Economic Commission for Europe**Inland Transport Committee****World Forum for Harmonization of Vehicle Regulations****Working Party on Passive Safety****Seventy-sixth session**

**Proposal of a New UN Regulation on the Installation of Safety-Belts,
Restraint Systems, Child Restraint Systems,
ISOFIX Child Restraint Systems and i-Size Child Restraint Systems****Proposal for the 01 Series of Amendments****Submitted by the expert from Japan ***

The text reproduced below was prepared by the expert from Japan to revise the proposal adopted at the seventy-fourth session of GRSP as ECE/TRANS/WP.29/GRSP/2023/32, that was amended by annex IV of ECE/TRANS/WP.29/GRSP/74 (GRSP-74-24-Rev.5). This would be a new series of amendments to the UN Regulation on the Installation of Safety-Belts, Restraint Systems, Child Restraint Systems, ISOFIX Child Restraint Systems and i-Size Child Restraint Systems, that resulted from the split of UN Regulation No. 16 into three new UN Regulations. The modifications to the existing text of the proposal of new UN Regulation (ECE/TRANS/WP.29/2024/152) are marked in bold for new or strikethrough for deleted characters.

Figure 1
Photo of the Buckle Strap Path of the UN Regulation No. 129 Test Bench

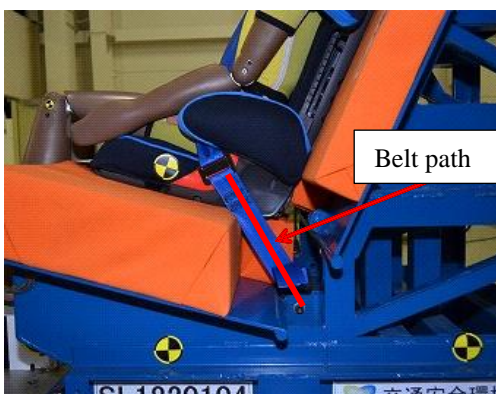
4. The strap's paths between the effective safety-belt anchorage and the buckle are normally straight like the test bench specified in UN Regulation No. 129 (figure 1). However, the strap's paths between the effective belt-anchorage and the buckle of some vehicles in the market are not straight and are curved along the cushion (figure 2).

Figure 2
Photo of the Buckle Strap Path When Not Straight

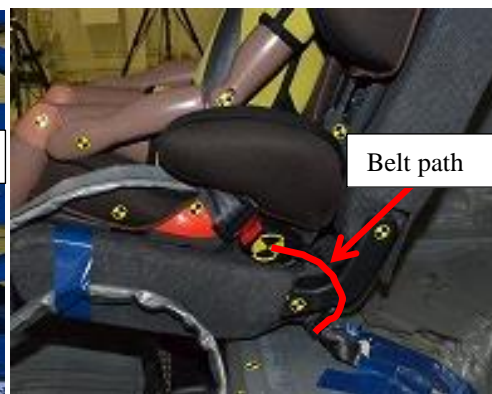
5. When the strap's paths between the effective belt anchorage and the buckle are not straight, the occupants can be thrown forward significantly in a frontal impact accident. If an occupant is seated in the booster seat attached by ISOFIX, there are cases where the seatbelt will slip up to the neck and submarining will occur (referred to in GRSP-69-24). This would increase the risk of injury to the neck and abdomen of a child occupant. In addition, the chest injury of the dummy increases. Figure 3 shows the relationship between the amount of slack in the buckle strap and the maximum 3 ms dummy chest acceleration for two types of Child Restraint Systems. When the buckle slack was 50 mm (see the left graph of figure 3), the maximum chest acceleration in one Child Restraint System approached the criteria of UN

- 5.2.3.1. The difference between the actual strap length and the straight-line distance between the point EA and Bd point shall be 80 mm or less.**
- The above requirements may be shown by the actual vehicle, parts, drawings, or 3D data at the manufacturer's discretion.**

Figure 3
Relationship between the Amount of Slack of the Buckle Strap and Maximum 3ms Dummy Chest Acceleration

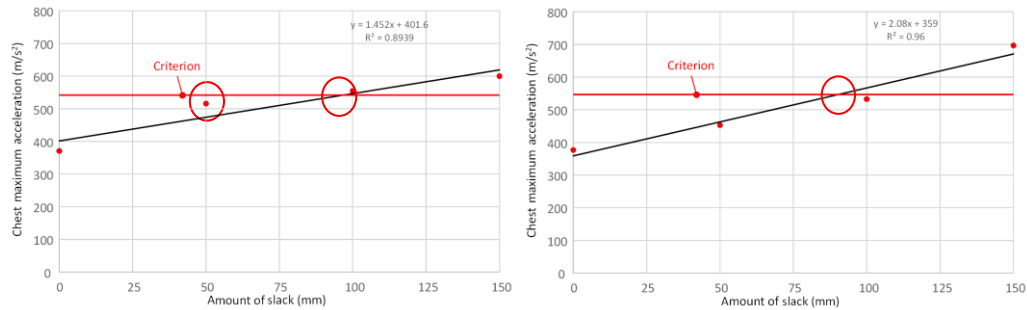
Regulation No. 129. When the buckle slack was around 80 mm (see the right graph of figure 3), the maximum chest acceleration exceeded the noted criteria.

6. The increased slack in the buckle belt increased the passenger's excursion, which is detrimental to occupant safety (see GRSP-70-32).
7. Therefore, we recommend limiting the slack of the buckle belt.
8. These amendments mitigate the negative effects on the safety of the occupants.
